Docket Item # 6
BAR CASE # 2009-0027

BAR Meeting
March 18, 2009

ISSUE: Addition and Alterations
APPLICANT: Stephanie Dimond for James McCall
LOCATION: 1110 Prince Street
ZONE: RM/Residential

Figure 9: Proposed elevations

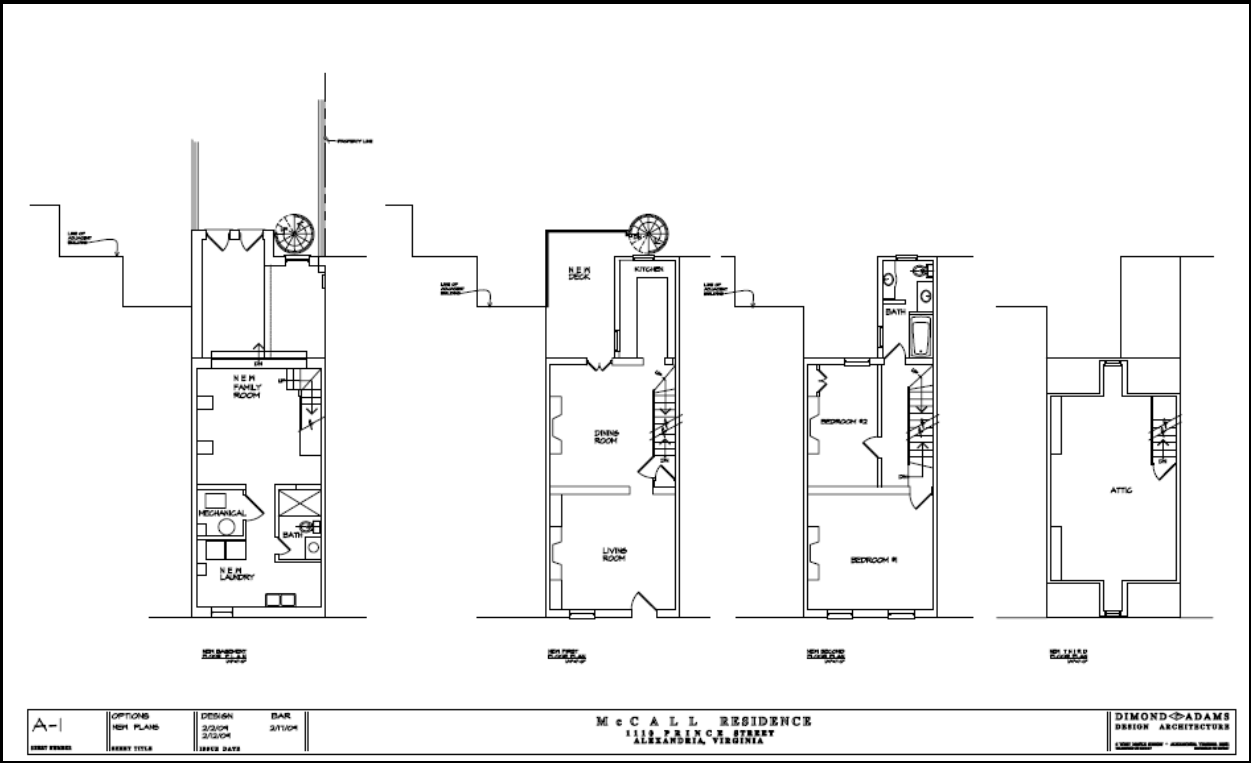
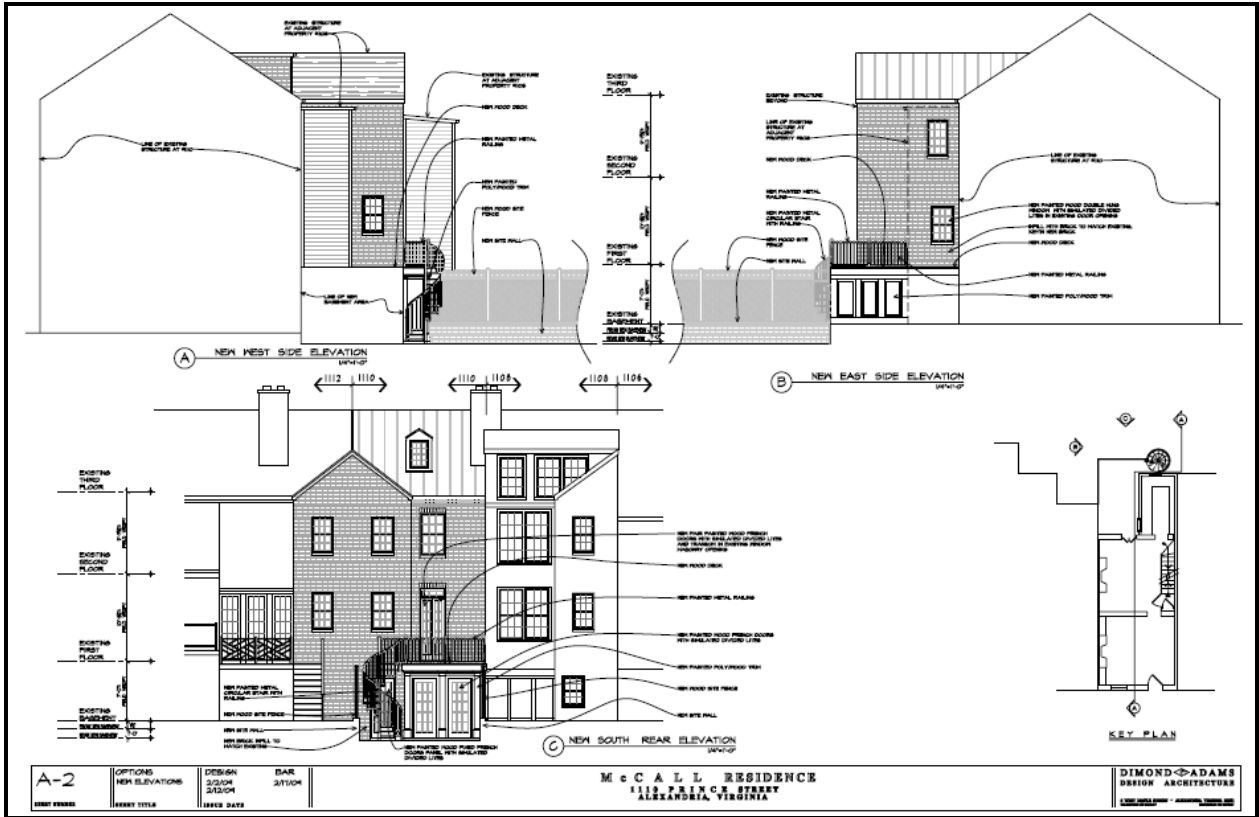
While the main block of the building retains a high degree of historic integrity, Staff supports the use of this non-traditional material on the new addition only for several reasons. First, it is being used on new construction on a basement level addition. Second, the windows and doors proposed for the addition and on the first floor will be constructed of wood. Third, Staff is cognizant of the applicant's desire to limit the amount of maintenance, especially on the east elevation where the addition will be constructed on the shared property line.

While single-glazed, true-divided-light wood windows are preferable, the *Design Guidelines* and the Board generally allow for double-insulated, simulated-divided-light wood windows and doors on new construction or in areas with limited visibility, both of which apply in this case. Therefore, Staff finds that the proposed windows and doors are appropriate. Furthermore, after discussions with Staff, the applicant agreed to use an even smaller and more historically appropriate muntin width of 5/8 inch, rather than the originally proposed 7/8 inch muntin.
